Interactive comment on “Technical note: Water table mapping accounting for river-aquifer connectivity and human pressure” by Mathias Maillot et al.

Received and published: 21 August 2019

Fig. 1. Fig. a: Water table level compared to topographic level at LWC sampling points. The red symbols correspond to the samples affected by the pumping wells, the black symbols correspond to the unaffected

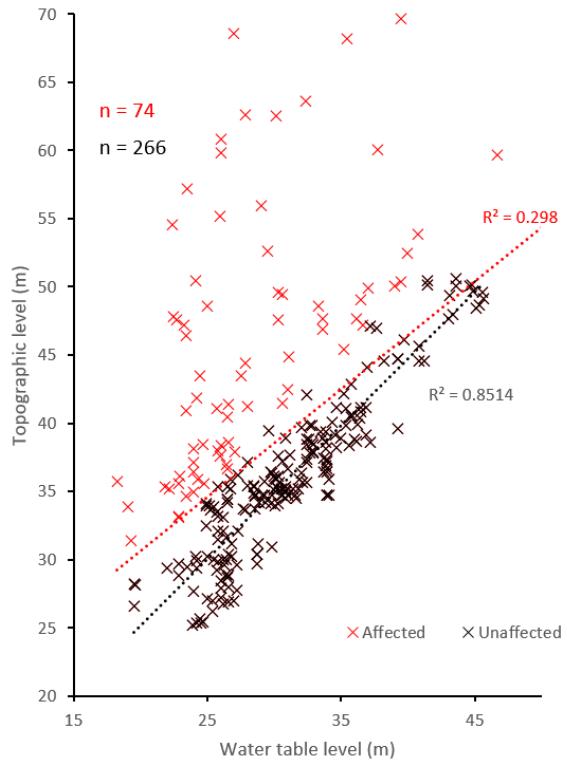
P4 L18-29: This part is still very much unclear. First of all, there should be a conceptual discussion about the effect of pumping. Namely, it must be recognized that the effect of pumping is not only punctual. Hence, nowhere will the water table be really natural/unaffected. In this view, it is not even clear why any data should be removed. Secondly, you write that the location of pumping wells is required. Do you have these data? It seems not, otherwise you would not need to use a threshold value on UZD. But this should be said! Thirdly, a rationale for the employed 10 m threshold is still lacking. Fourthly, you write that the variographic studies are performed on the second category of data. Does this mean that the rest of the analysis uses all the data from both categories?

Some justifications were added P5 L3-7 to explain the identification of affected piezometers. The Dupuit-Forchheimer assumption is not valid within the capture zone of a pumping well. Therefore, the head is not hydrostatic (Grubbs et al., 1993), the piezometric value and the topography are not correlated within its capture zone. We noted that there is no correlation between the piezometric value and the topography for the locations where UZD exceeds 10 m (Fig.a). Without the exact knowledge of pumping wells location, we assume that these samples are located within the pumping wells capture zone. Indeed, this differentiation was only used to construct the experimental

variograms to which the variogram model are fitted. The rest of the analysis uses all the data from both categories.
